CHRYSLER / DODGE MINIVAN SERVICE MANUAL

2005 - 2007

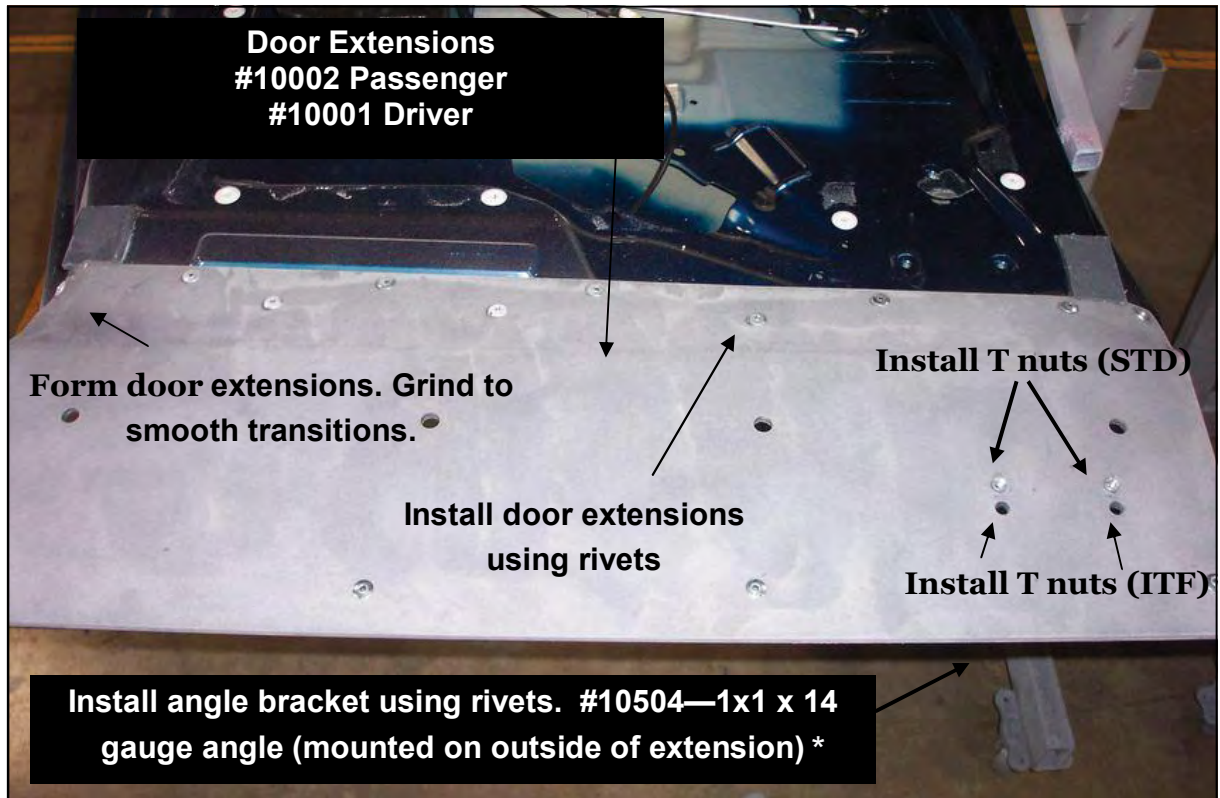
*Starting 8/11/2009 the Metal Angle Bracket was replaced by a Plastic Angle Bracket. Refer to Service Bulletin #09168 (Order Qty 1 #B08180-DP6, Qty 5 #10269 – 3/16 Rivets per door, each with #1133074 - #10 Washer)
